APPENDIX 1

From: Diane Cafferty [Diane.Cafferty@ribblevalley.gov.uk]
Sent: 20 February 2013 09:52
To: General Email
Subject: RE: Land at Elker Mews, Billington RV/2013/ENQ/00010

PROPOSED PLANS & ELEVATIONS

REQUEST FOR PRE-APPLICATION ADVICE RELATING TO PROPOSED DWELLING AT ELKER MEWS, WHALLEY ROAD, BILLINGTON.

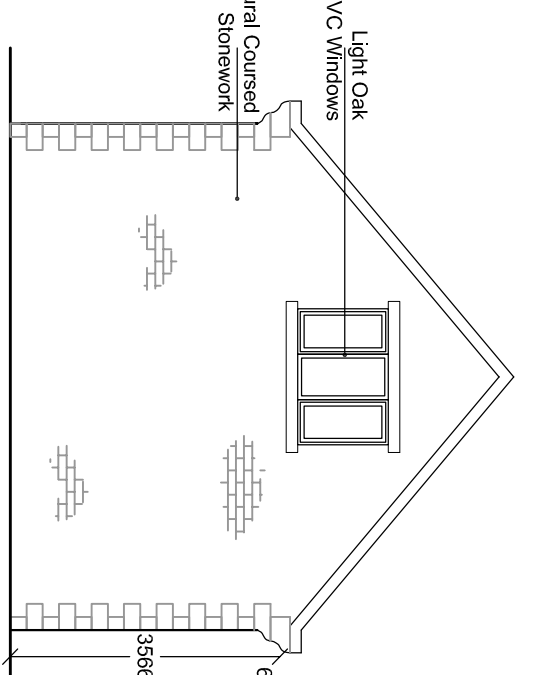
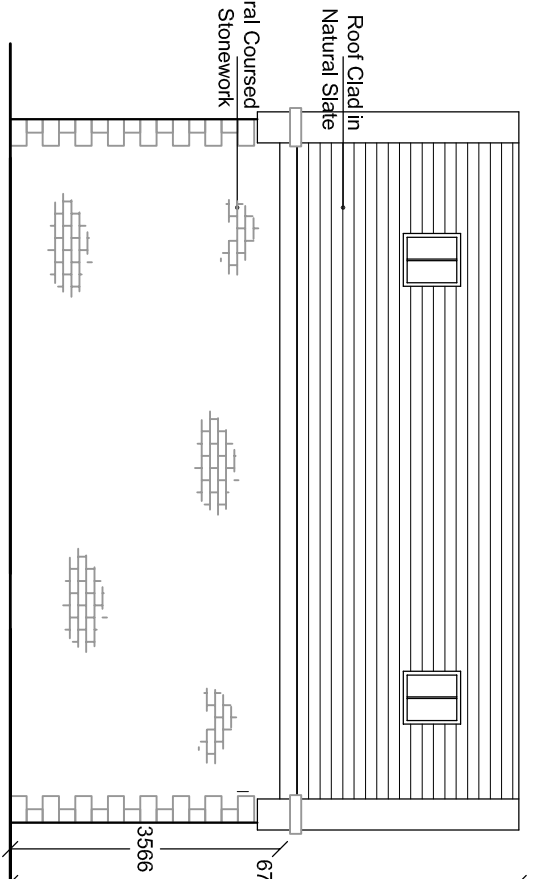
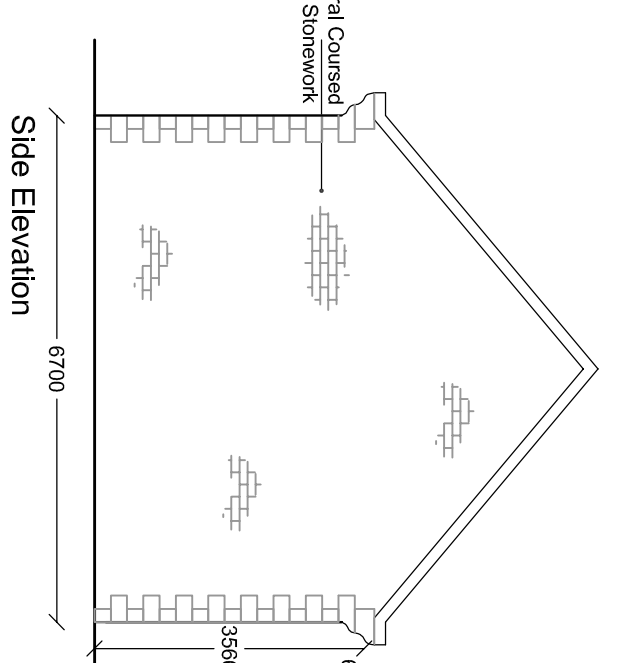
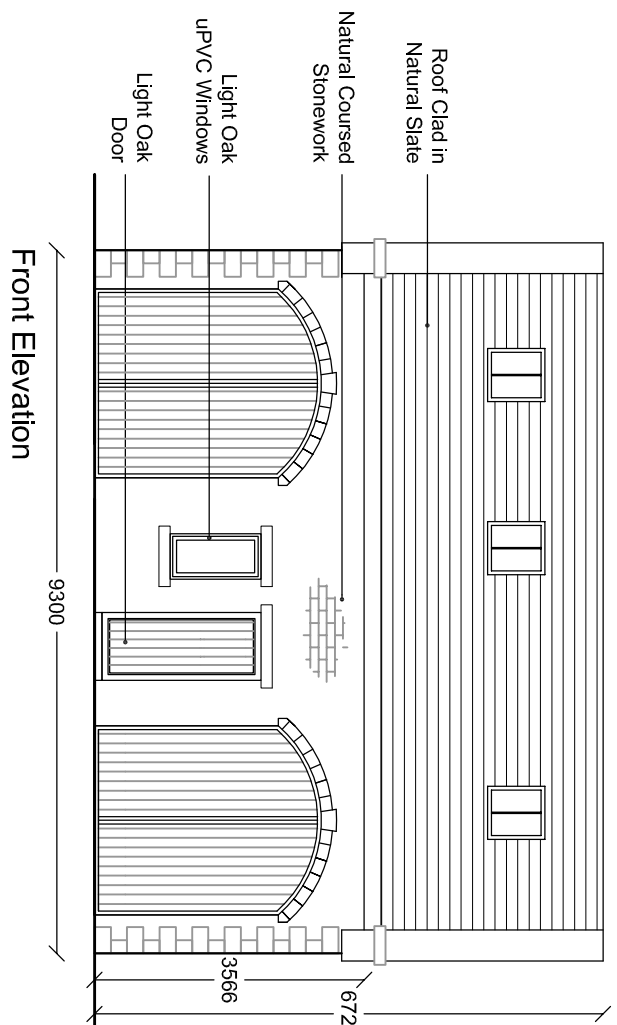
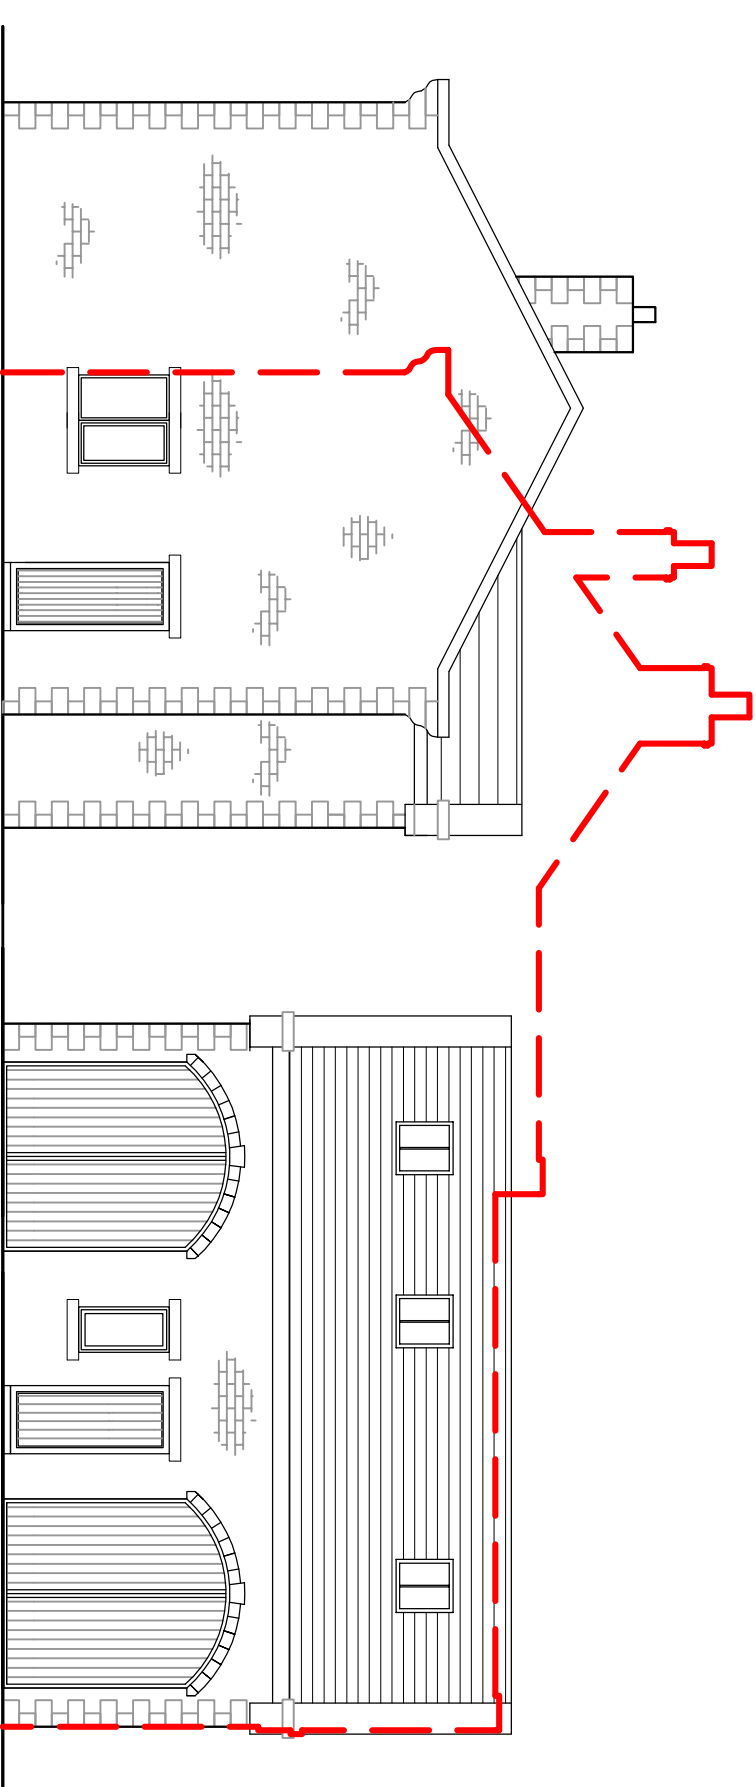
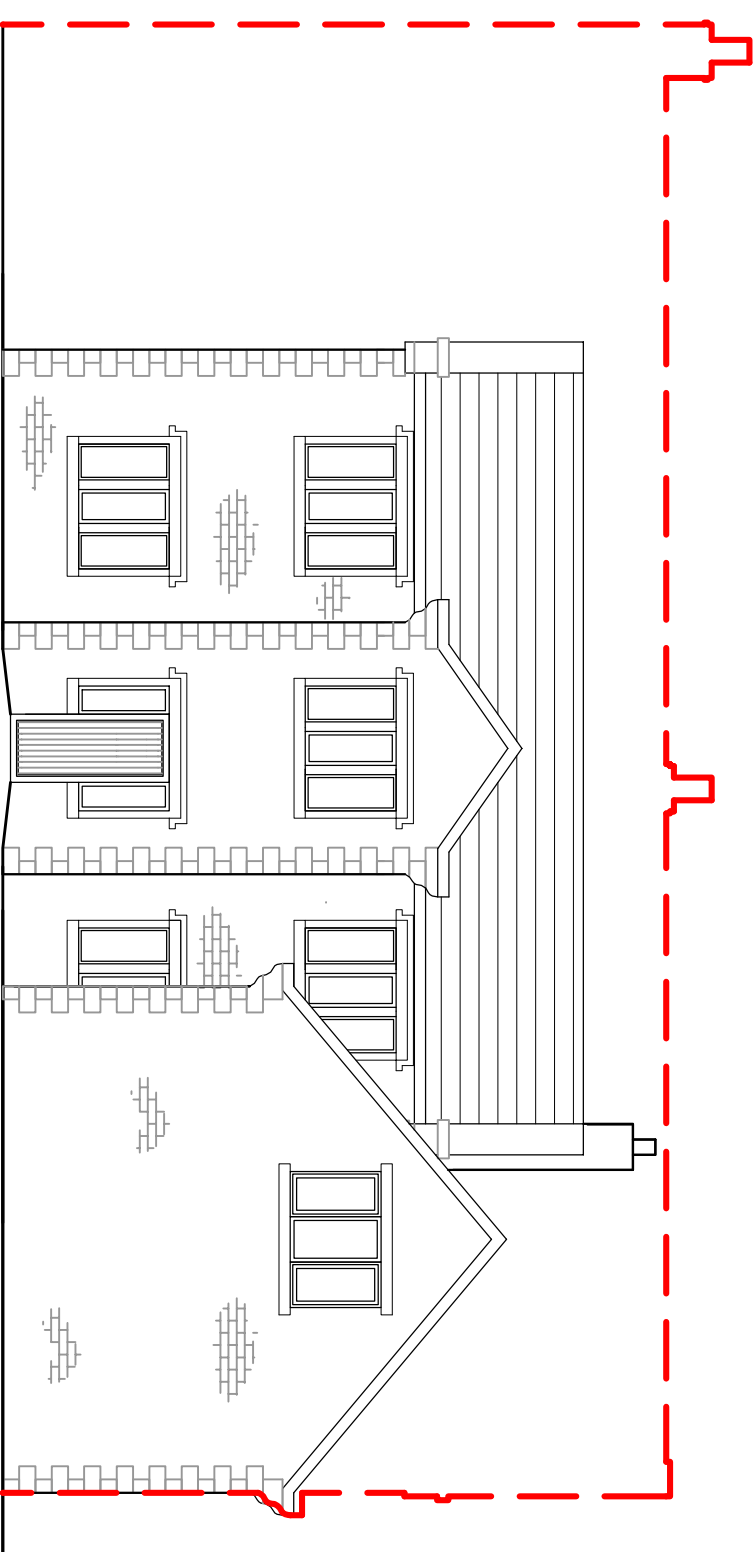
Thank you for your email. Having looked at your further revised scheme, based on the level of information supplied I consider this to be more in keeping with the area and consider that the separation of the units is beneficial. The reduction in scale is welcomed.

SITE PLAN	
Site: Proposed Development Plot at Elker Mews, Billington BB7 9NF	Client: WHALLEY DEVELOPMENTS LTD
	Drawn: NYB
	Date: 19.02.13
	Scale: 1:500 @ A3
	Project No: WHA/02 Dwg 02A
	Amendments: A

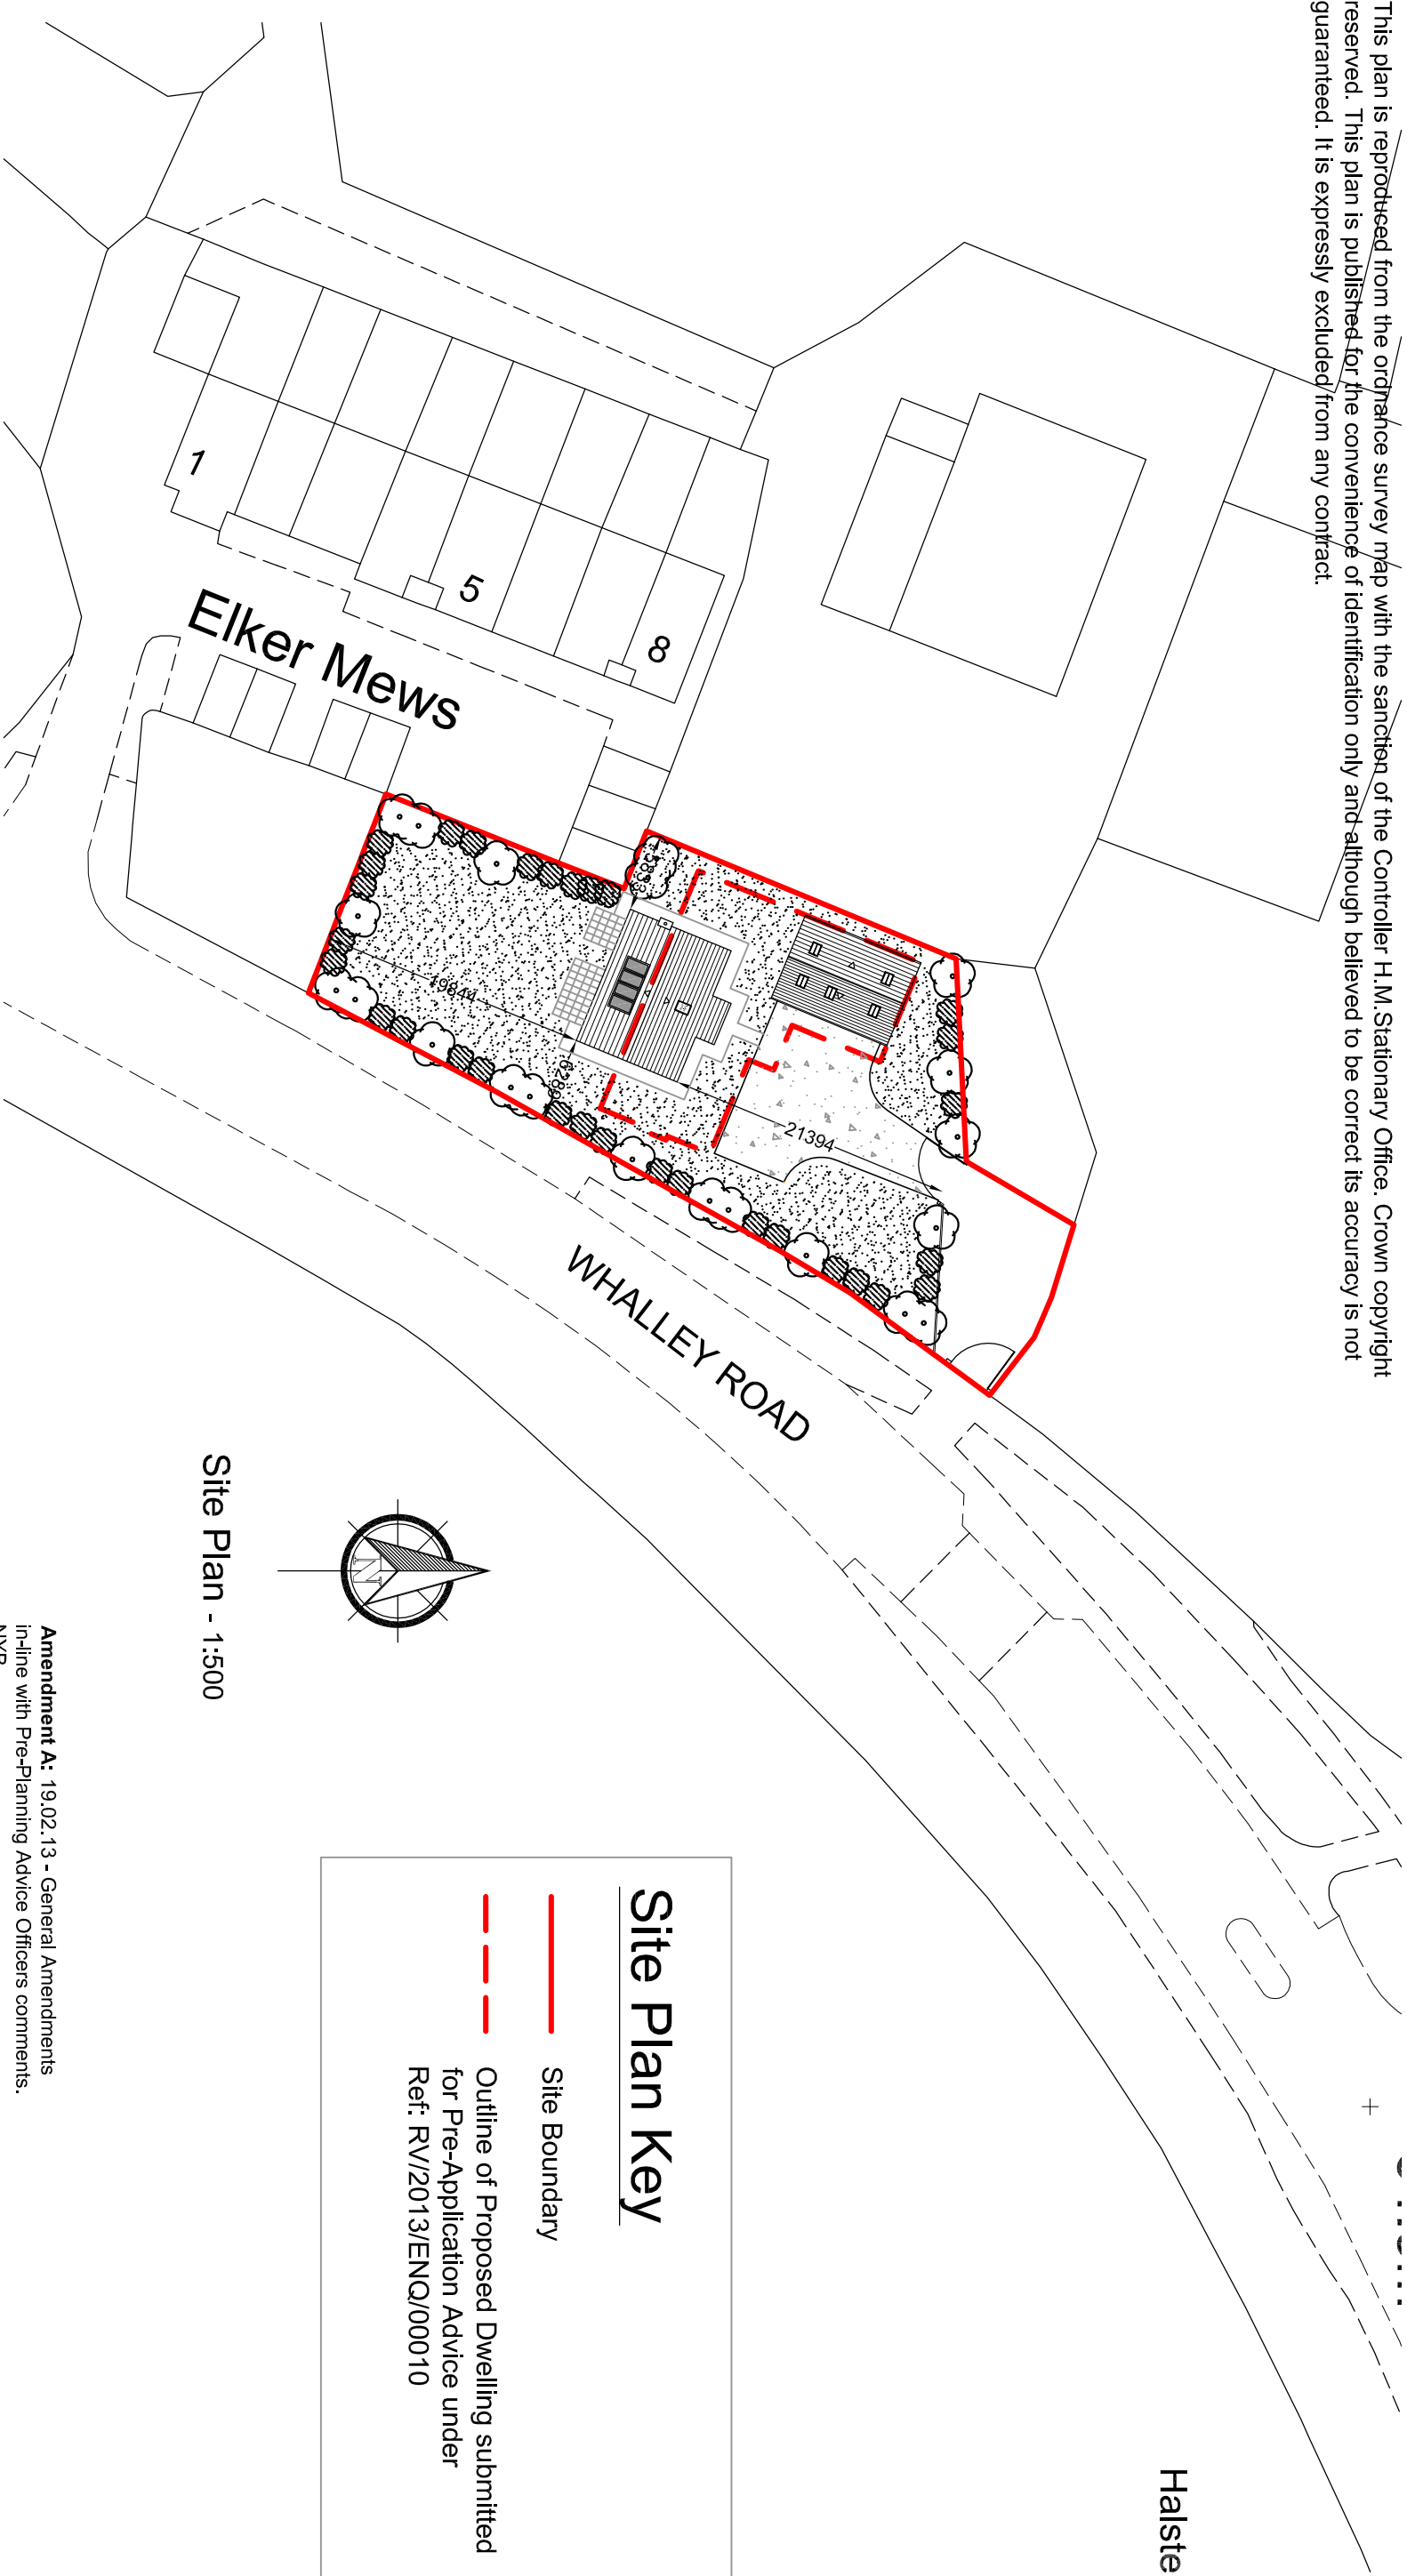
1 If the access is to be gated then the gate needs to be set into the site. Currently, whilst Mark [Hornby] suggests that a vehicle can draw clear of the carriageway if the gate is closed, the position of this vehicle would obstruct cyclists wishing to enter the cycle lane which starts at this location.

2 The proposal shows 2 vehicle spaces. Clarification is needed of the number of bedrooms proposed, and a site plan showing the parking spaces and turning area provided.

3 Looking at Streetview, the access appears to be well used, possibly by the large agricultural building to the west. Will the proposed access be shared or will the agricultural building be accessed elsewhere and if so where will this be.
